CONTAMINATION ASSESSMENT REPORT ADDENDUM WITH TRANSMITTAL FOR SITE
1122 OUTLYING LANDING FIELD BRONSON NAS PENSACOLA FL
04/23/1999
NAVY PUBLIC WORKS CENTER

**CONTAMINATION ASSESSMENT REPORT ADDENDUM
SITE 1122, U.S. NAVY OUTLYING LANDING FIELD (OLF)
BRONSON FIELD**

RE: CONTAMINATION ASSESSMENT REPORT ADDENDUM (CARA),
U.S. NAVY OUTLYING FIELD (OLF) BRONSON, SITE 1122, PENSACOLA,
FLORIDA

FIGURE 1: USGS TOPOGRAPHIC MAP

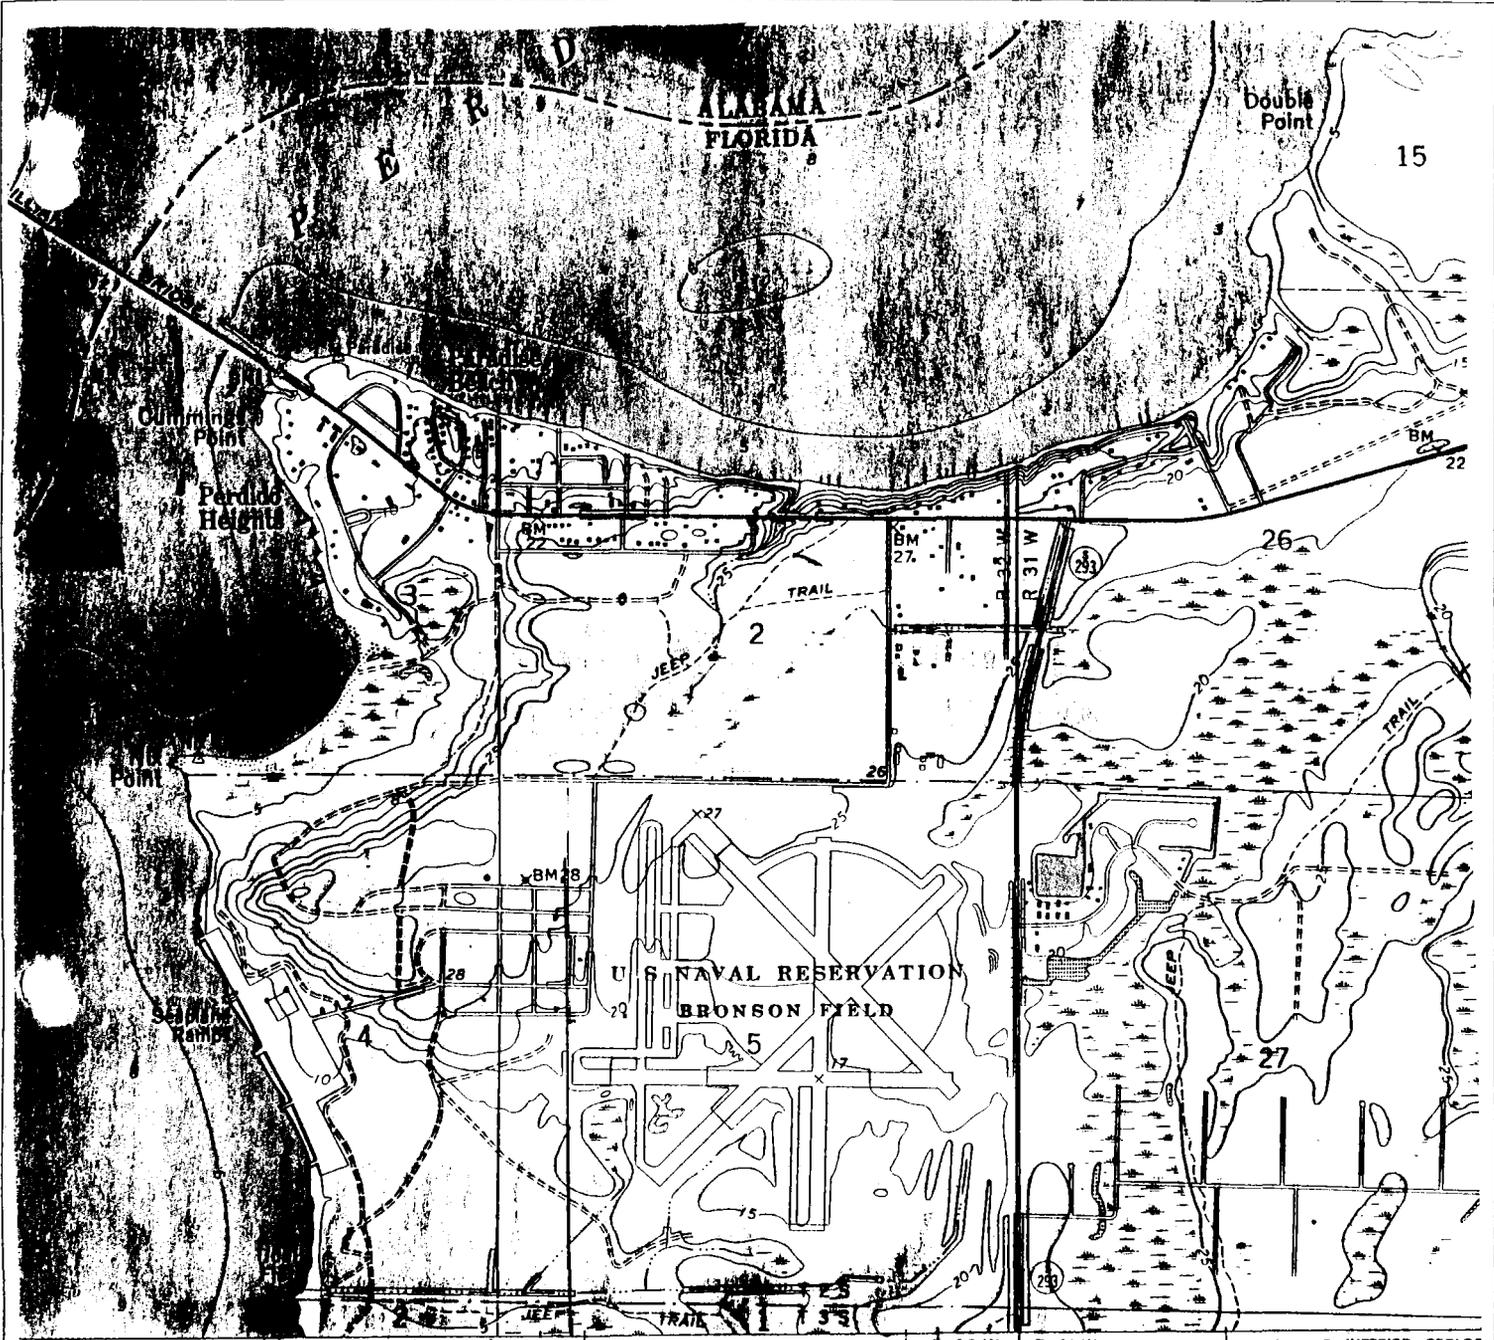
- (a) Copy of portion of most recent USGS topographic map, including quadrangle name and scale, that clearly identifies the site in relation to the surrounding area. (62-770.600(7)(a)2.)

(1)(a) A copy of the portion of the USGS topographic map, including quadrangle name and scale, that clearly identifies Site 1122, Bronson Field in relation to the surrounding area is shown in Appendix B, Figure 1. Site 1122, Bronson Field is located in Section 4 and 5, Township 2S, Range 32W, as referenced on the Lillian, ALA.-FLA. U.S. Geological Survey (USGS) Topographic Quadrangle Map.

NAVY PUBLIC WORKS CENTER PENSACOLA, FLORIDA	
SCALE:	FIGURE 3
DRAWN BY: DWG. NO. REVISED BY:	
1944 SITE MAP OF SITE 1122 SITE 1122, BRONSON FIELD	
CLIENT: NAS ENVIRONMENTAL DEPARTMENT, NAS, PENSACOLA

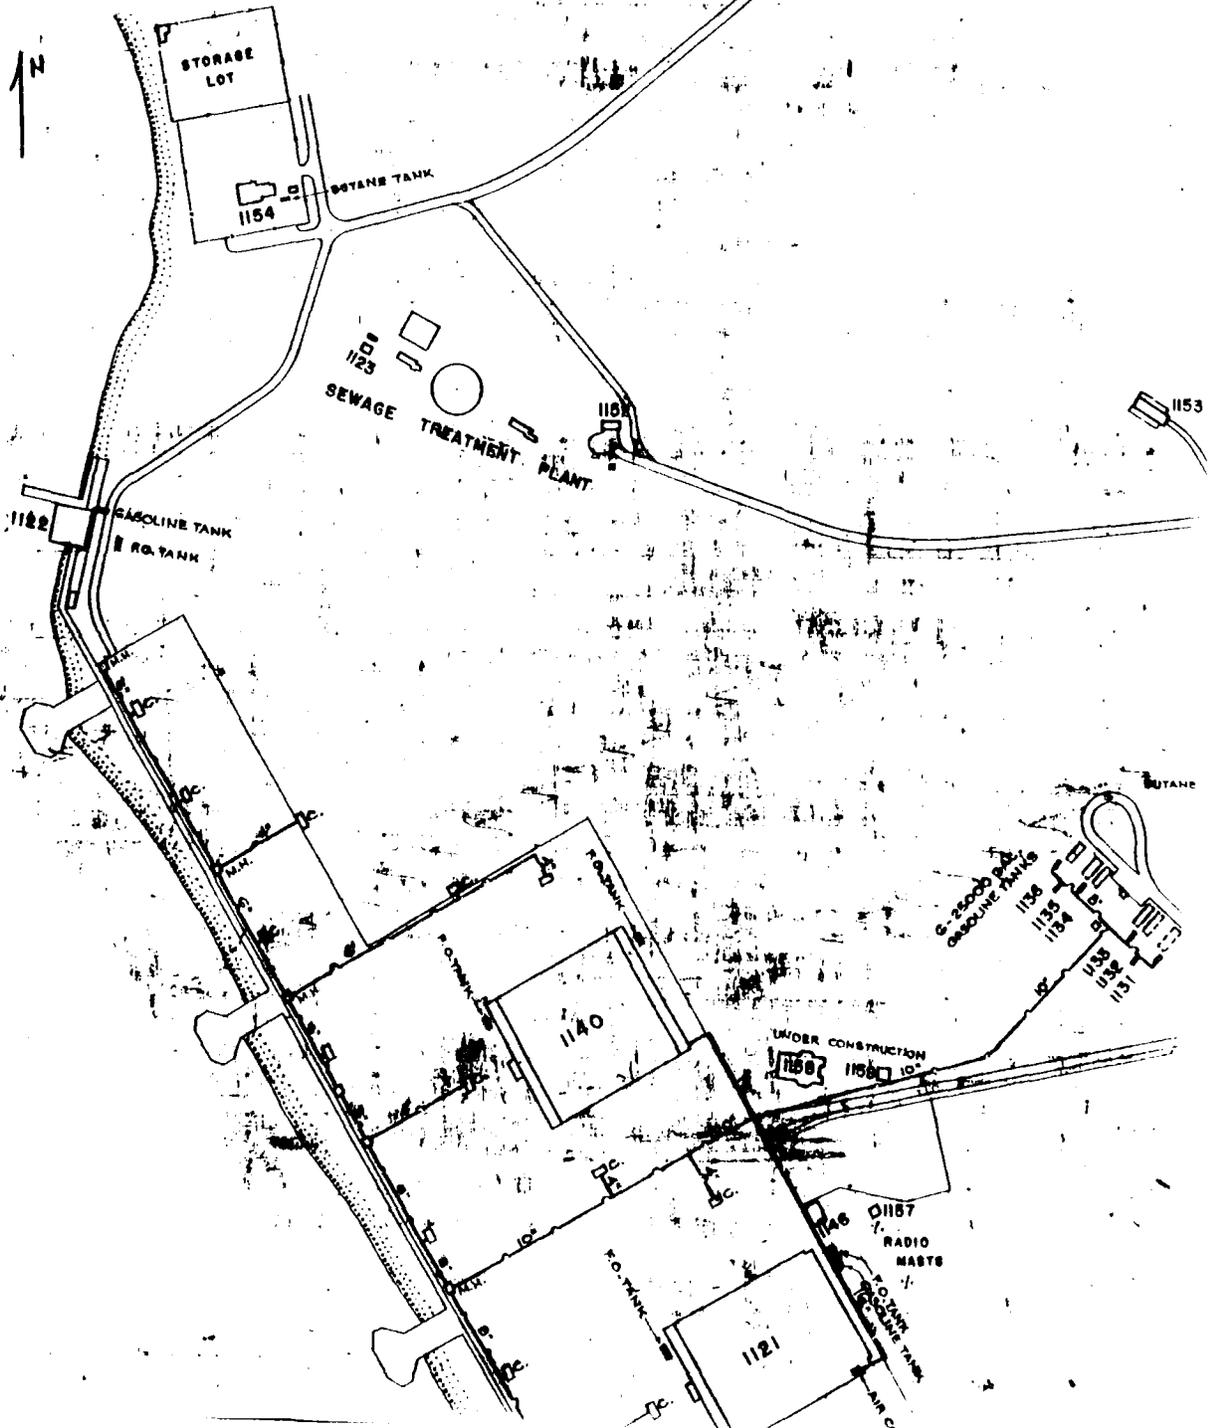
- (c) One or more site maps showing all pertinent features (tanks, integral piping, dispensers, monitoring wells, buildings, land cover, utilities and subsurface stormwater drainage structures). (62-770.600(7)(a)4.)

(1)(c) Site maps showing all pertinent features of Site 1122 are included in Appendix D, Figures 3, 4 and 5. Figure 3 is a map of Bronson Field as it looked in 1944. Figure 3 shows the site of previous USTs, underground piping and buildings. Figure 4, a site specific map of Site 1122, was drawn by PWC in 1997. Figure 4 shows the current layout of Site 1122, including the location of monitoring wells MW-1 thru MW-14. Figure 5 shows the stormwater drainage structure (open drainage ditch) existing at

NAVY PUBLIC WORKS CENTER PENSACOLA, FLORIDA		
SCALE:	FIGURE 7	DRAWN BY: DWG. NO. REVISED BY:
GROUNDWATER FLOW DIRECTION MAP (8/18/99), ITE 1122, BRONSON FIELD		
CLIENT: NAS ENVIRONMENTAL DEPARTMENT, NAS PENSACOLA

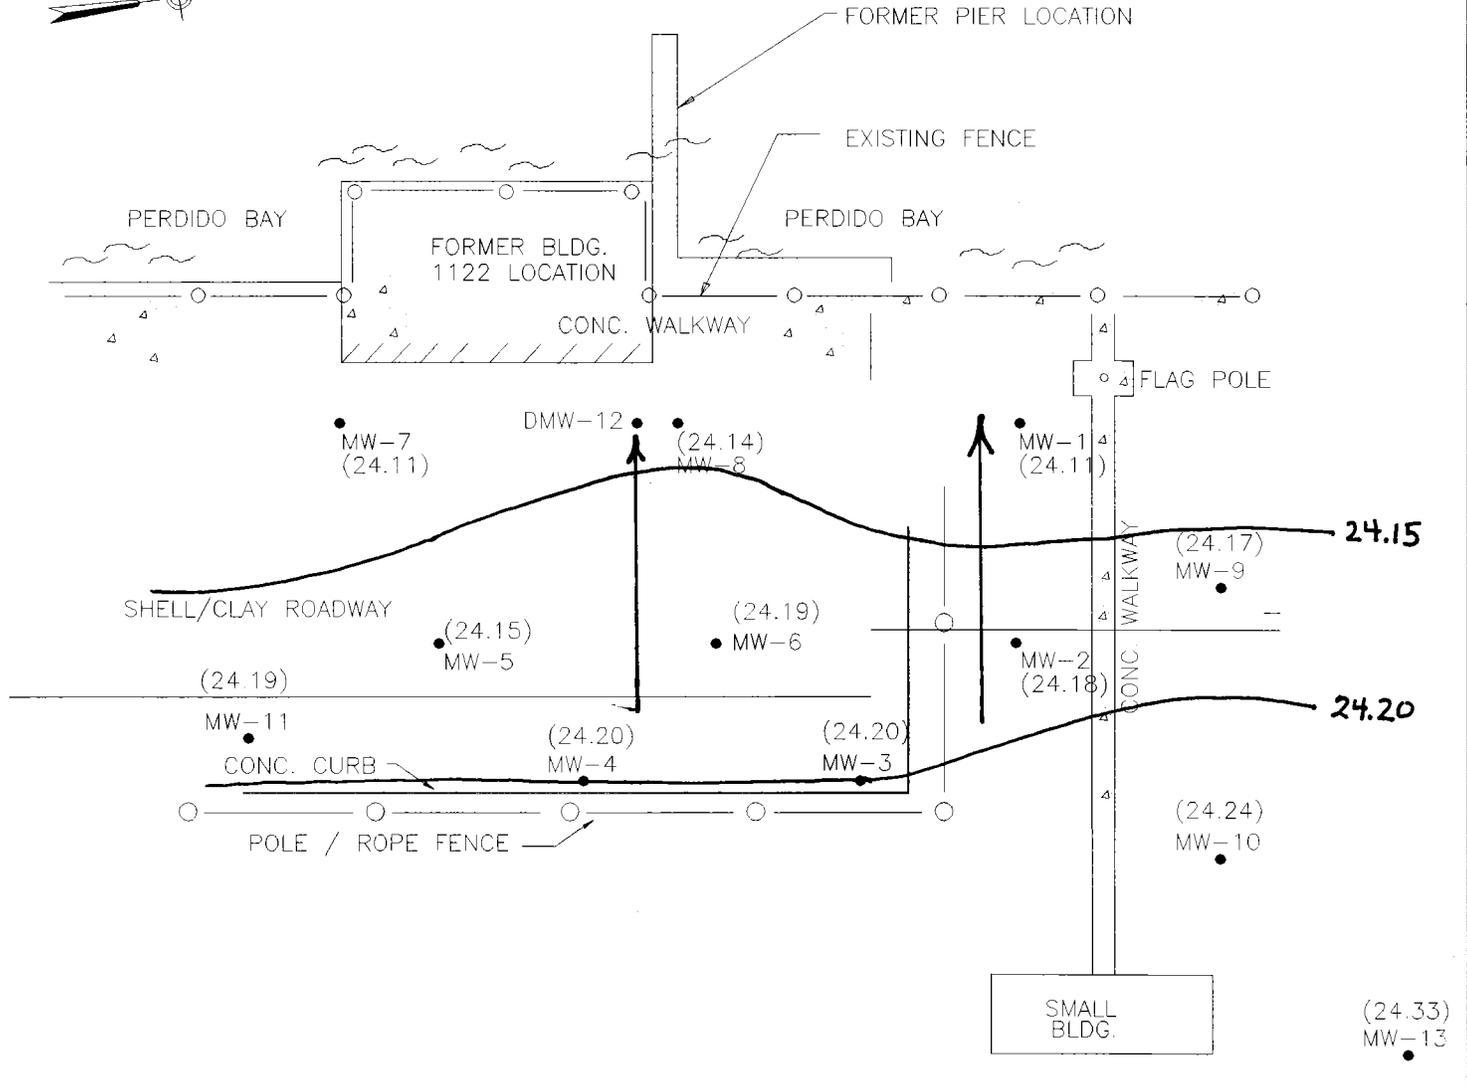
- (e) Water table elevations obtained at least twice and at least one month apart. (62-770.600(7)(a)8.)
 - (f) Determination of tidal influence on groundwater flow. (62-770.600(7)(a)9.)

(1)(e) Water table elevations recorded at Site 1122 from monitoring well MW-1 thru MW-14 on August 18, 1998, and October 21, 1998, are found in Appendix I, Table III and Table IV, respectively. Groundwater Flow Direction Maps prepared from groundwater elevations recorded on August 18, 1998, and October 21, 1998, are shown in Appendix I, Figure 7 and Figure 8, respectively. The Groundwater Flow Direction Maps indicate that the groundwater flow direction at the site to be toward the west-northwest.

NAVY PUBLIC WORKS CENTER PENSACOLA, FLORIDA		
SCALE:	FIGURE 8	DRAWN BY: DWG. NO:
		REVISED BY:
GROUNDWATER FLOW DIRECTION MAP (10/21/98), ITE 1122, BRONSON FIELD		
CLIENT: NAS ENVIRONMENTAL DEPARTMENT, NAS PENSACOLA

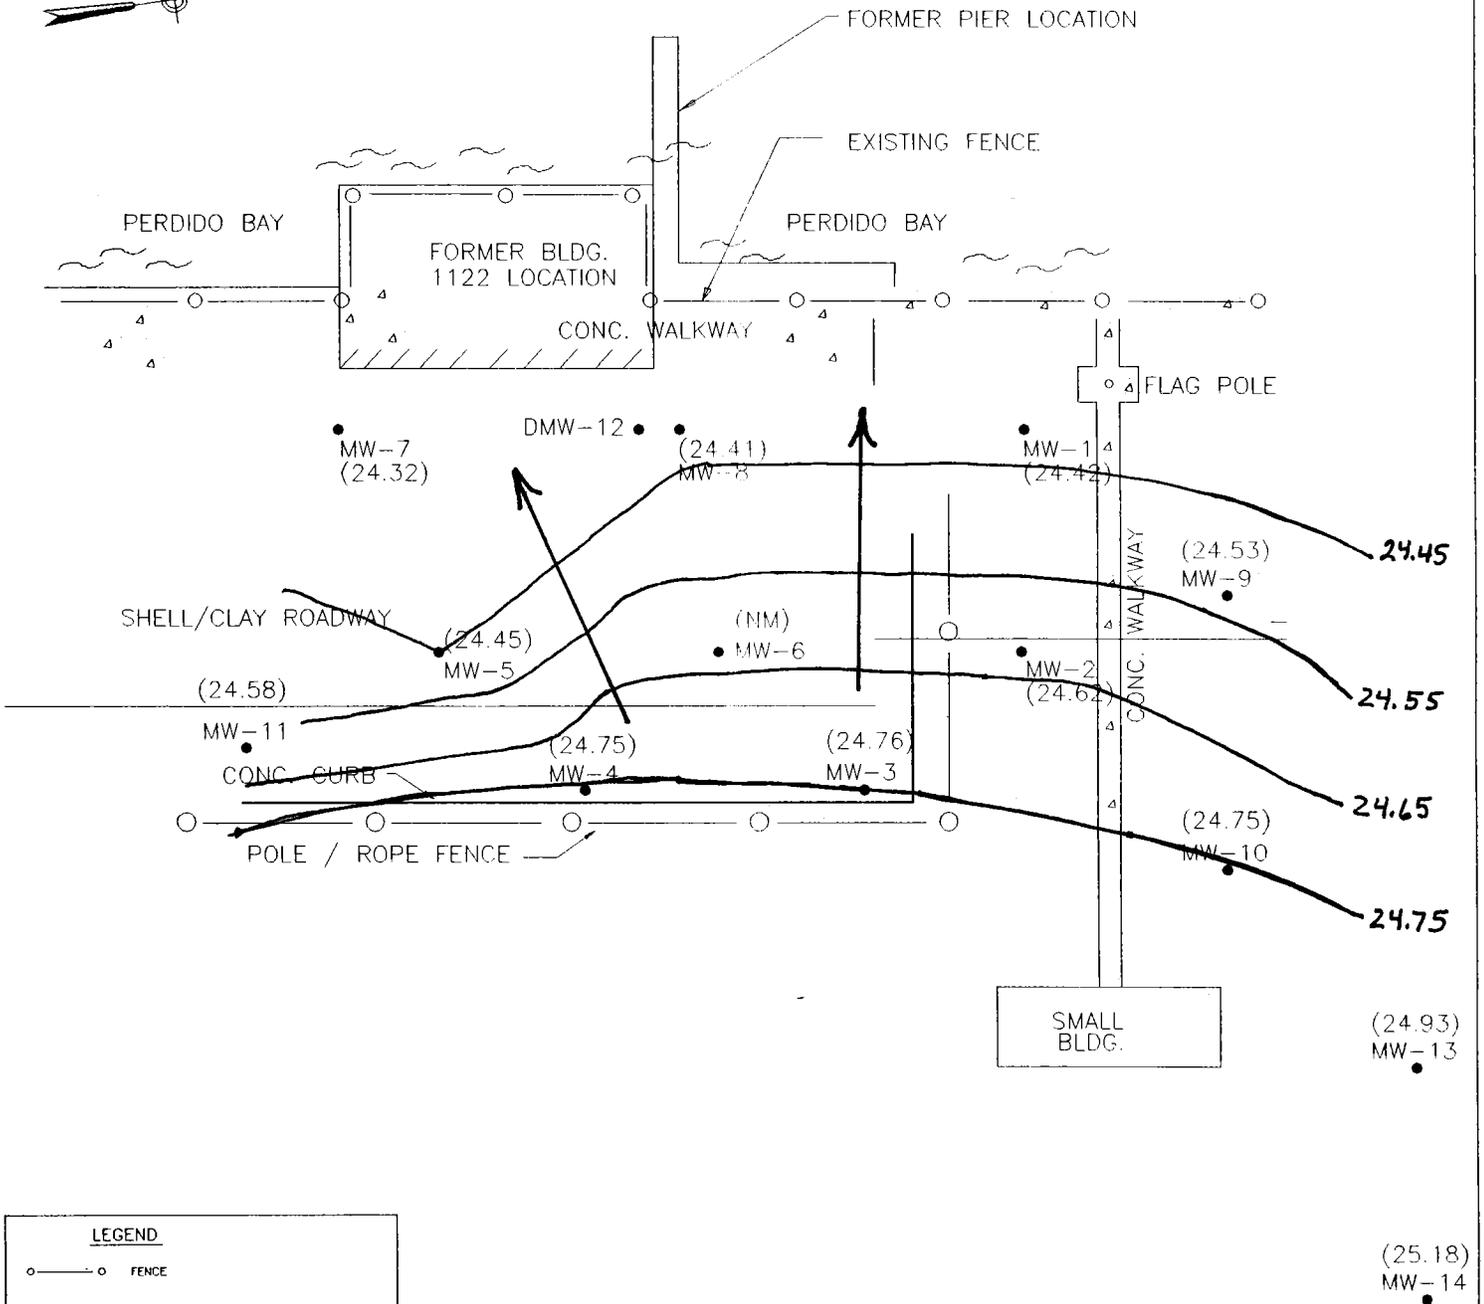
- (a) Groundwater sampling and analyses of representative monitoring wells should have occurred within 270 days of Site Assessment Report submittal. Most of the groundwater analytical data for this site is greater than one year old. Representative monitoring wells should be resampled and analyzed for chemicals of concern detected in the previous sampling event (TRPH, EDB, and tetrachloroethene (DMW-12 only)). Before groundwater sampling occurs, water table elevations in all monitoring wells should be taken to determine horizontal and vertical groundwater flow directions and gradients.

(3)(a) Representative monitoring wells were resampled and analyzed, on August 18, 1998, and October 21, 1998, for chemicals of concern detected in the previous sampling event (TRPH, EDB, and tetrachloroethene [DMW-12 only]). Water table elevations from monitoring wells MW-1 through MW-13 were taken before groundwater sampling occurred on August 18, 1998, and on October 21, 1998, to determine horizontal and vertical groundwater flow directions and gradients. Groundwater table elevations taken on August 18, 1998, from monitoring wells MW-1 thru MW-13 are shown in Appendix I, Table III. A Groundwater Flow Direction Map, using groundwater elevations measured in the August 18, 1998, sampling event, is included in Appendix I, Figure 7. Groundwater table elevations taken on October 21, 1998, from monitoring wells MW-1 thru MW-14 are shown in Appendix I, Table IV. A Groundwater Flow Direction Map, using groundwater elevations measured in the October 21, 1998, sampling event, is included in Appendix I, Figure 8.

**FIGURE 10: MAP OF WATER SUPPLY WELLS
AT BRONSON FIELD**

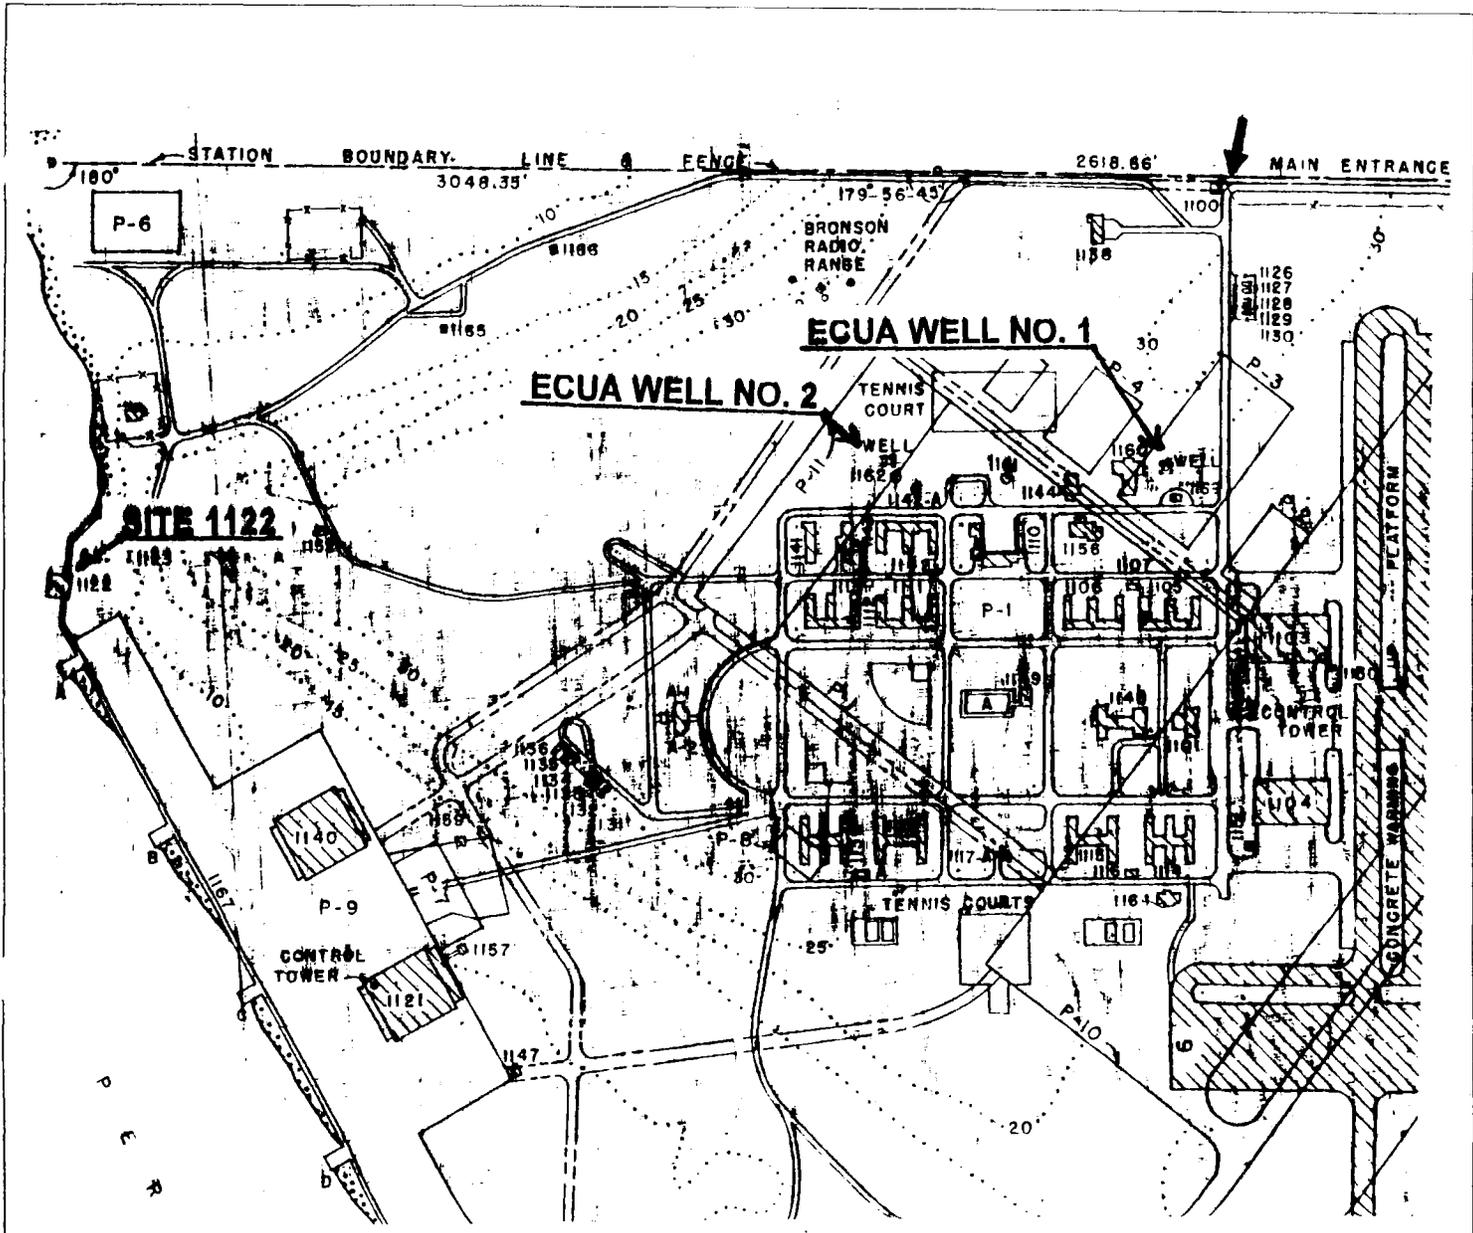
- (g) A figure showing water supply wells in relation to the site. (62-770.600(7)(a)11.) (Figure 1-6 does not locate Site 1122 on the map in relation to the water supply wells)

(1)(g) A map showing the location of water supply well #1 and water supply well #2 in relation to Site 1122 is included in Appendix K, Figure 10. Both wells are located within a one mile radius of the site, but are not located within a 1/4 mile radius of the site.
